## Submission to Draft Wilton Growth Area Development Control Plan

RE: Submission on Draft Wilton Growth Area Development Control Plan 2019

**RE: Submission to the Draft Wilton Growth Area Development Control Plan 2019**

### **Submission by Governor's Hill on Draft Wilton Development Control Plan**

Figure 1-2

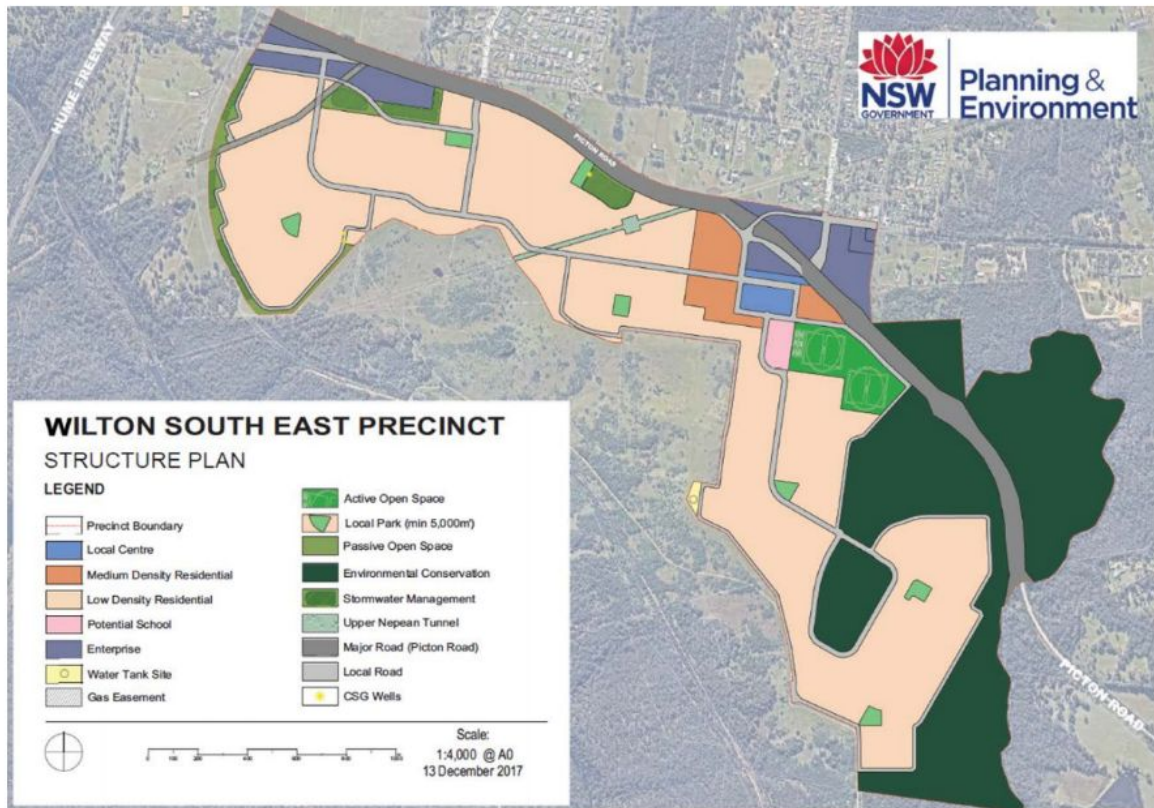
Clause 1 above states *buffers are necessary to the conservation areas including existing and future bushland sites*, Clause 11 also talks of this interface *provide a sensitive urban interface that supports and enhances the significance of corridors and reserves*. however we have a road wrapping around the whole site there is nothing to mitigate the edge effects of conservation areas meeting either stage 1 or stage 5 & 6.

**Figure 5: Priority Conservation Lands from the Cumberland Plain Recovery Plan and Biobank Sites**

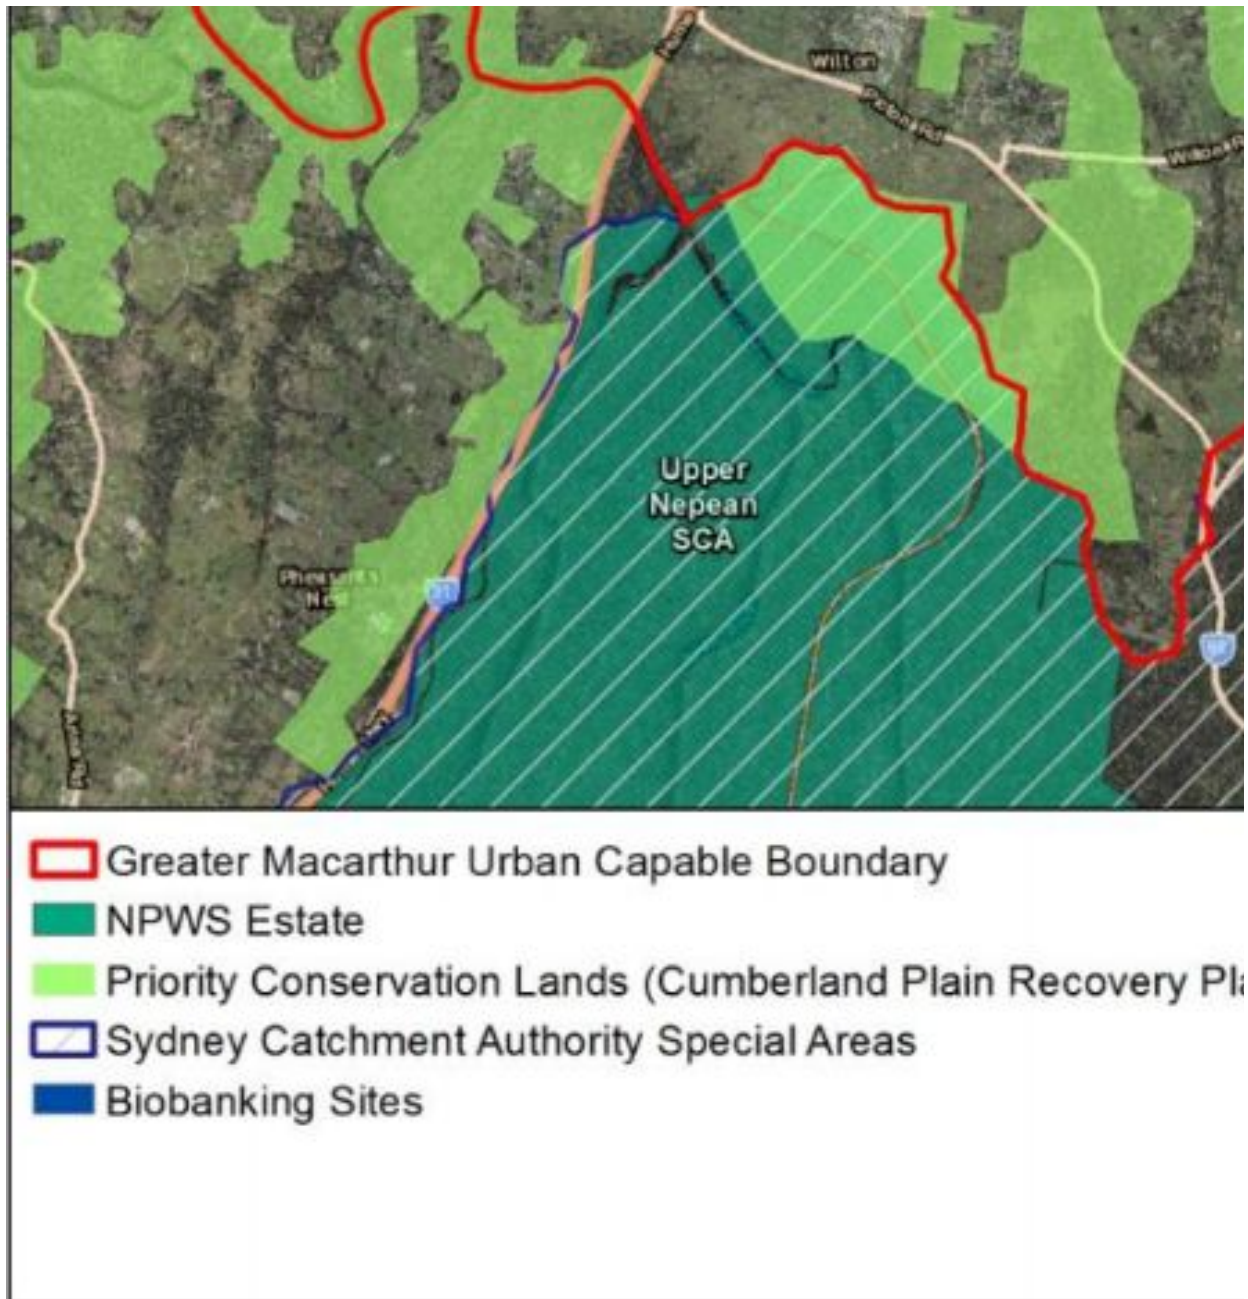
However the most disturbing thing in this report is how it relates to South East Wilton's so called 'Koala thumb'. The **Baseline Koala Survey for Wollondilly Shire** (April-May 2016) tracked a tagged female Koala 'Xhondo' across this landscape, and the **Greater Macarthur Investigation Area : Biodiversity Assessment Report** (September 2015) prepared for the NSW Department of Planning and Environment by Ecological Australia also identified this 'Koala Thumb' as a Priority Conservation Land under the Cumberland Plain Recovery Plan see the diagram on page 24 shown below.

Figure 1: Requested Amendment to DCP North Wilton Schedule Figure 3.1 to remove Stage 1 Staging “road gap” and improve long term connectivity to town centre

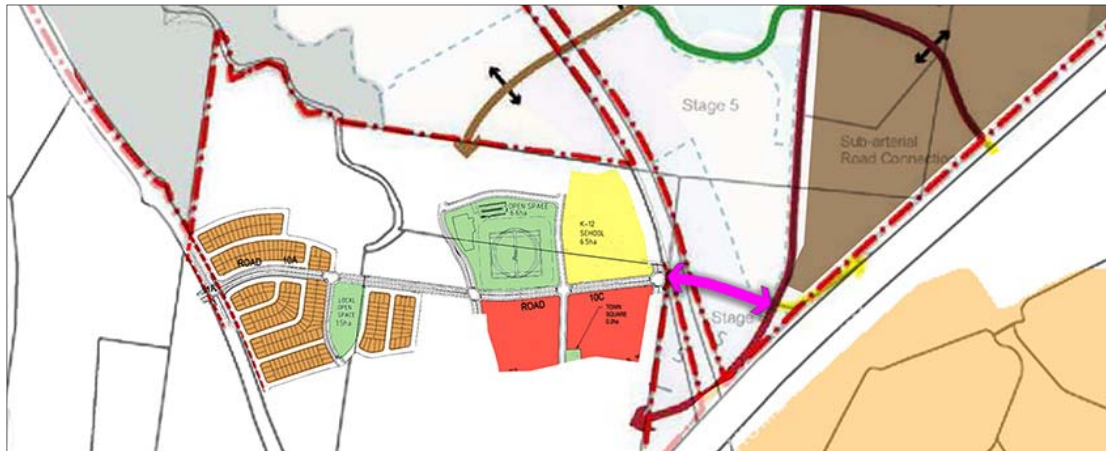
Request No. 28: Amend the road network map (Figure 3.1) in Clause 3.2 in the North Wilton Precinct Schedule to improve connectivity to the town centre and enhance access to the town centre for Wilton North residents as shown in Figure 1 below.

The road network map (figure 3.1) when correlated with the Wilton North Staging Plan (Figure 2.1) and the staging by Governor's Hill of the Town Centre Precinct illustrates a significant concern regarding connectivity to the town centre.

There is no direct between the northern part town centre (school and recreation facilities) and the Wilton North Precinct, Bingara Gorge and the Hume Highway, particularly in the early stages of the development of both precincts. (refer Staging Plan and road network plan in Attachment 2 and Figure 1 above).

These concerns suggest the need to provide a short collector road link that directly connects stage 1 of the Town Centre Precinct with Stage 1 of the Wilton North Precinct and Hume Highway intersection (refer to Plan in Figure 1). Relevantly we note that:

Figure 6 Connectivity and PCL analysis

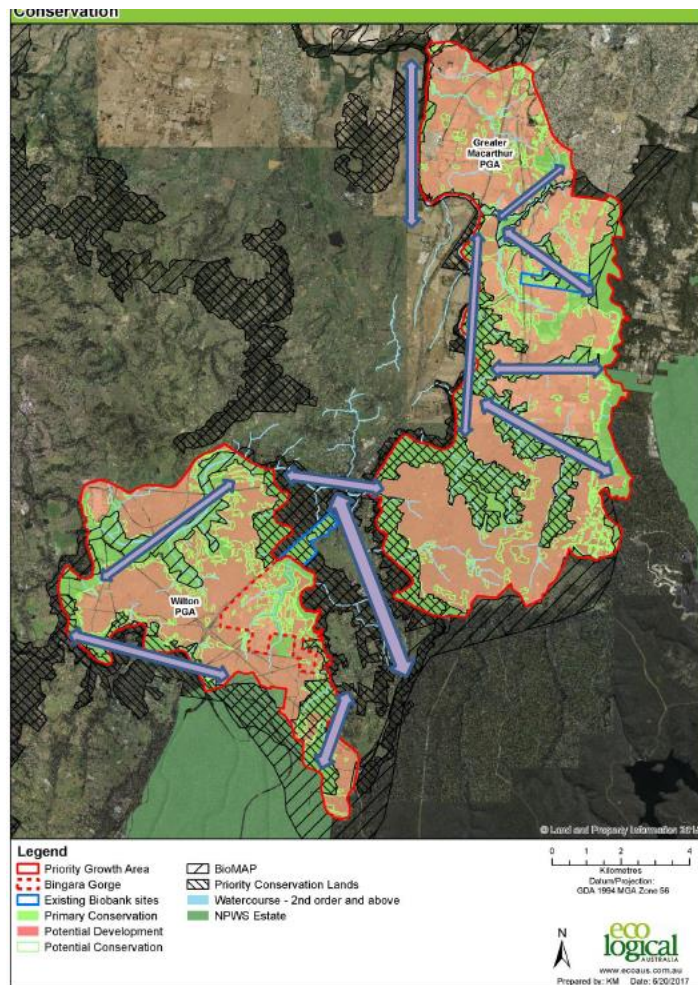
2. In the 2017 Report Conclusion p30 paragraph 4. The conservation network includes all lands identified in the "priority conservation lands" except for an area in the southern extent of the Wilton PGA where there is no vegetation. This is the finger, & derived native grass.
3. Figure 6 shows the priority conservation land with the finger included

Figure 5: Priority Conservation Lands from the Cumberland Plain Recovery Plan (DECCW 2010) and Biobank Sites

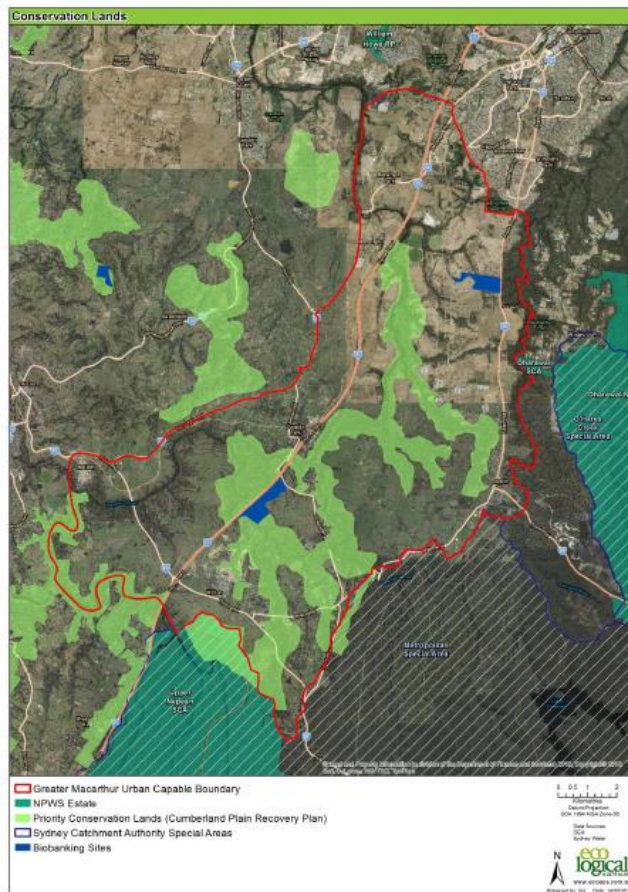
If you compare to the 2015 report: Figure 5 below you will see the priority conservation land area overlaid on the finger above. So this is how the 2017 maps look different, and how one sentence in the 2017 report, supported a change to the Interim Land Use Infrastructure Implementation Plan, which was then used to support the rezoning in 2018.

It appears therefore that development within the Urban Capable Boundary that was smaller in the 2015 report has been expanded in the 2017 report and the removal of the 2015 red flagged areas in the 2017 report is therefore of great concern. Therefore it is curious that the Document Tracking (ii) page of the 2017 report states that

**Figure 36**

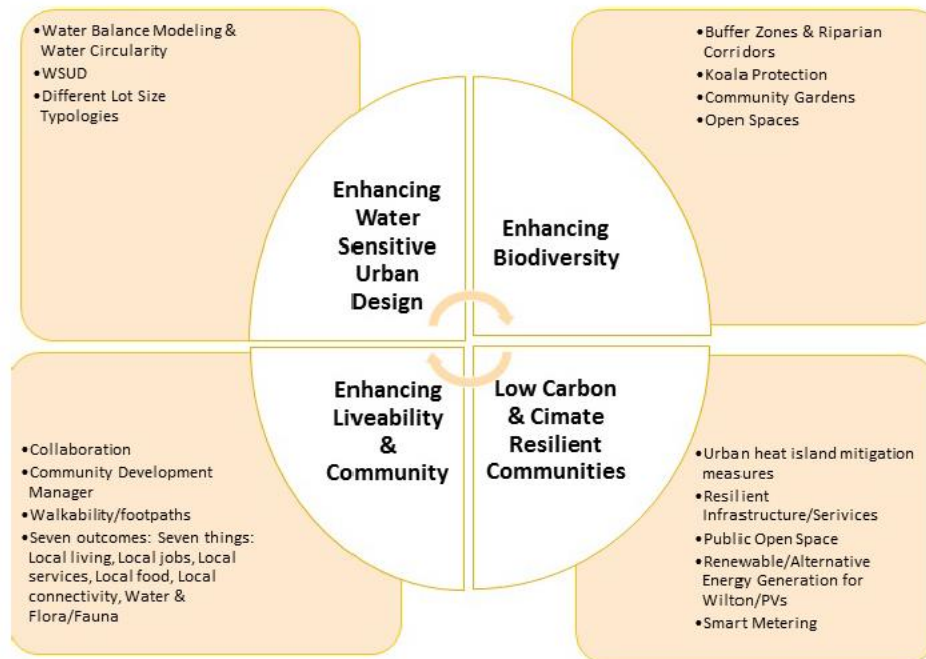
Multiple possible sustainability measures all having positive impacts for neighbourhoods are outlined in Figure 36. Many sustainability measures are reinforcing and complementary, producing dual or even multiple benefits. Sustainability action early in the planning and development cycle can have proportionally greater benefits, where there is often the most to gain from the introduction of new technologies and practices, e.g. alternative energy generation and water management.

Does the proposed Wilton Growth Area deliver serious mitigation or even adaptation to climate change exposures direct and indirect?

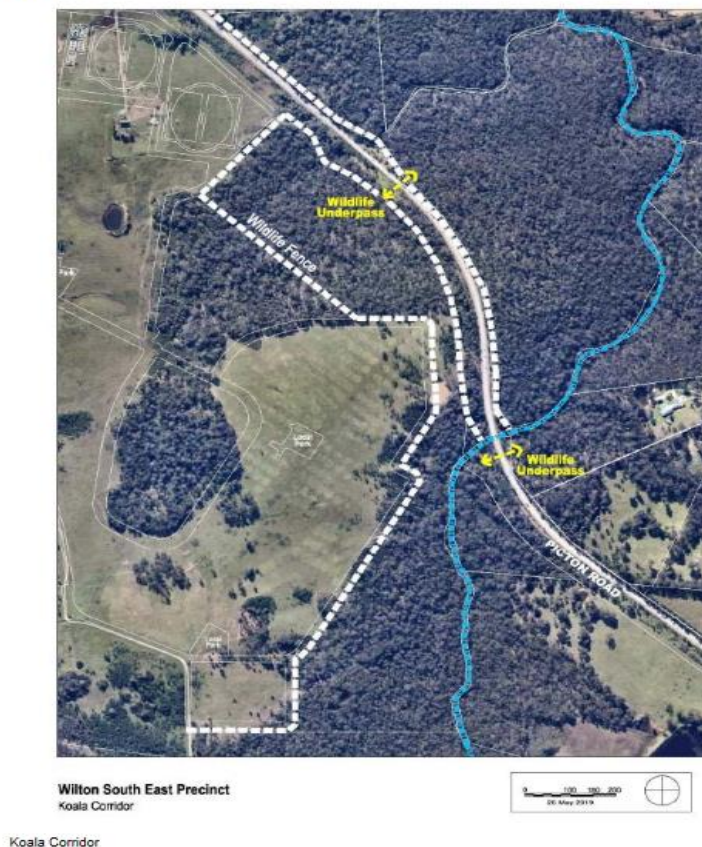
With this in mind we suggest two alternative approaches for consideration:

1. A requirement for the preparation of a more detailed "structure plan" that identifies location of key roads (collector status and above), major open space, drainage requirements, residential densities and fine grain land uses and the like. In areas where there is a boundary interface between two major landholdings, or land is held in fragmented ownership, the Council should be the party to prepare that plan (and recoup the costs via its S.7.11 Contributions Plan); and / or
2. A requirement for an initial development application for site areas that exceed a certain size (for example 20 hectares) to be a Concept Development Application pursuant to Section 4.22 of the Environmental Planning and Assessment Act 1979. The use of concept DAs has been guided by significant case law in the Land and Environment Court recently and will provide the level of certainty required by all parties.

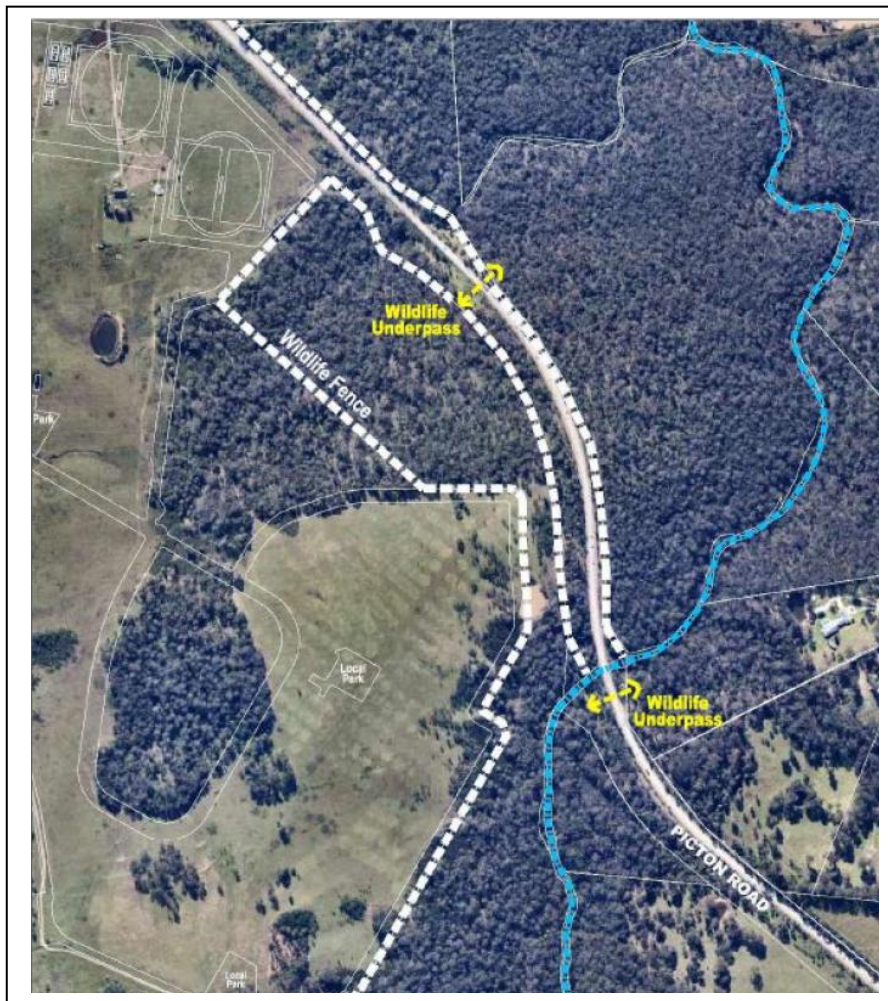
- This link is supported by investigation by consultants Urbis for DPIE in its “*Wilton Strategic Road Network Urban Design Assessment*” June 2018; and
- Investigations by consultants for Governor’s Hill have confirmed that there are no urban design, civil or environmental constraints to including this short road link and it can be accommodated in the Wilton North Structure Plan with minimal impact. These studies can be provided on request.
